# Cleveland City Planning Commission

Friday, March 31, 2023

**DF2022-070** – Mazzella Lifting Technologies Signage Expansion: Seeking Final Approval

## DF2023-004 – Rock & Roll Hall of Fame Expansion: Seeking Conceptual Design

# Section through Multipurpose & Drum

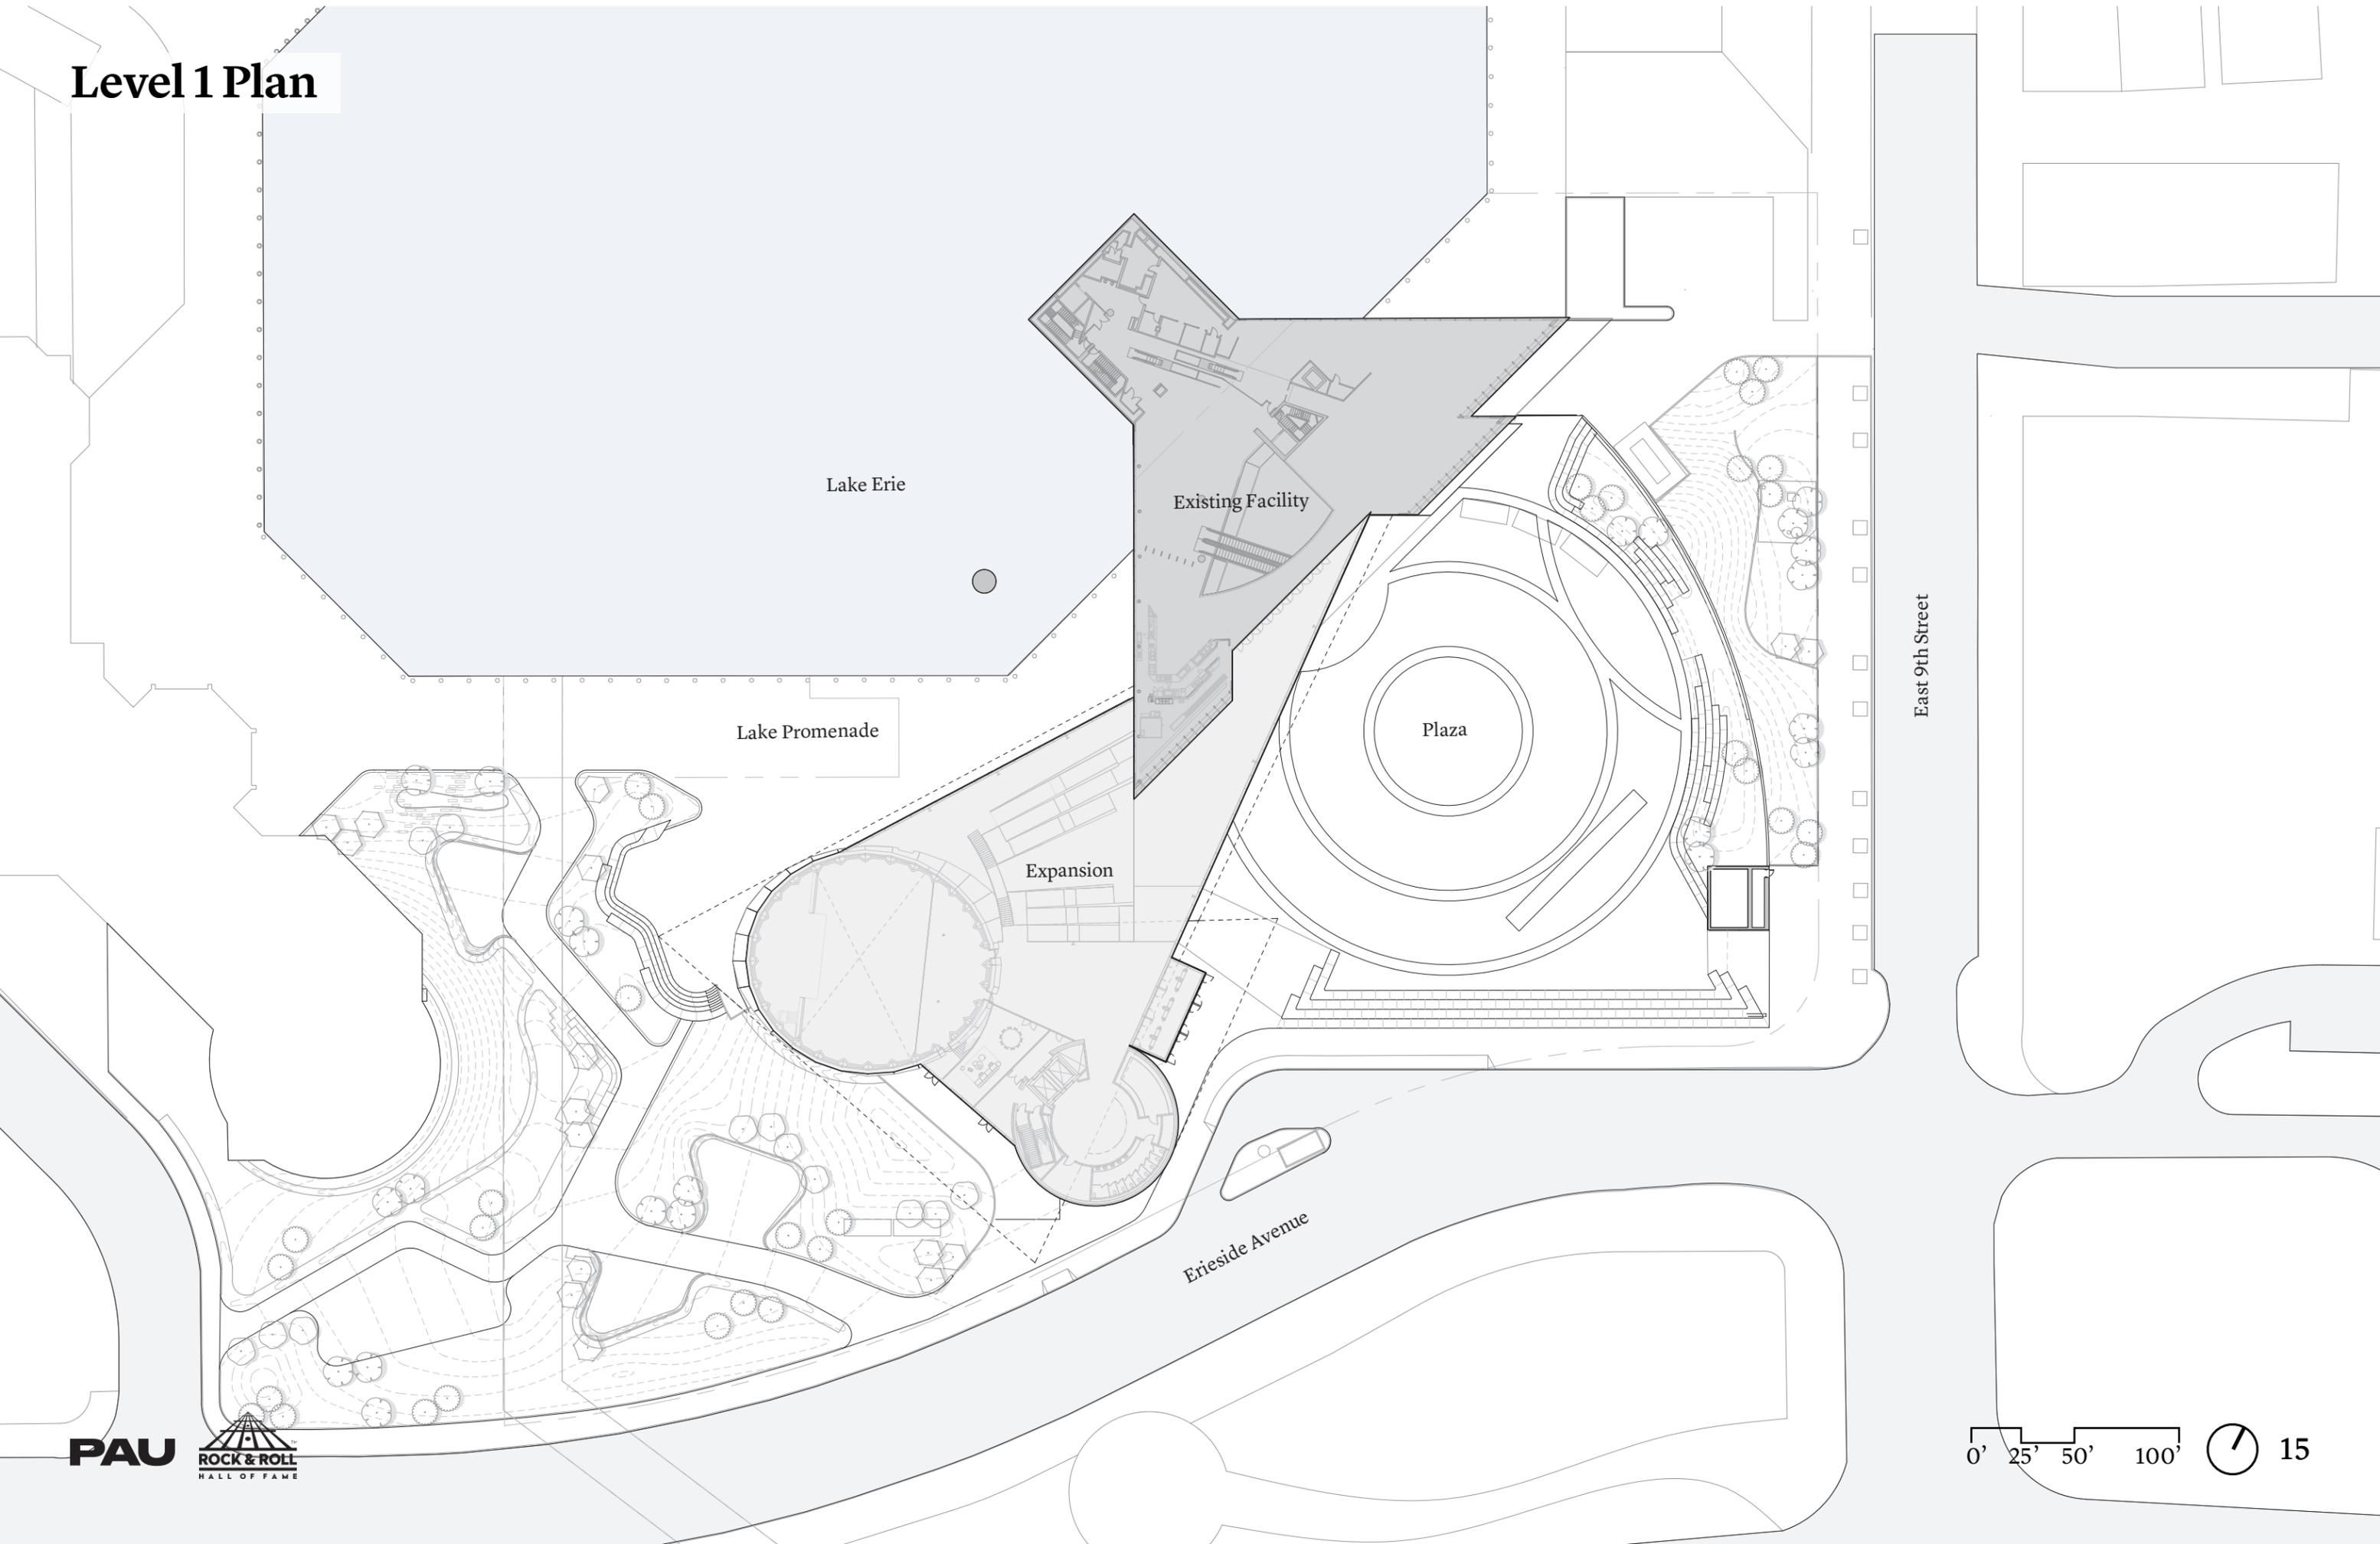
### Committee Recommendation: Approved with **Comments**

- Provide signage and wayfinding to the lakefront and surrounding downtown assets
- Create passive programming and public engagement opportunities along the proposed greenspace and at existing plaza
- Need to study the intersection between the new and existing architecture, and intersection of roof elements with walls; details are important to for longevity of the building and avoiding maintenance issues
- Reconsider the design of the entry element to better define the entry itself
- Reconsider the relationship between the iconic geometry of the architecture and proposed geometry of the path/landscape
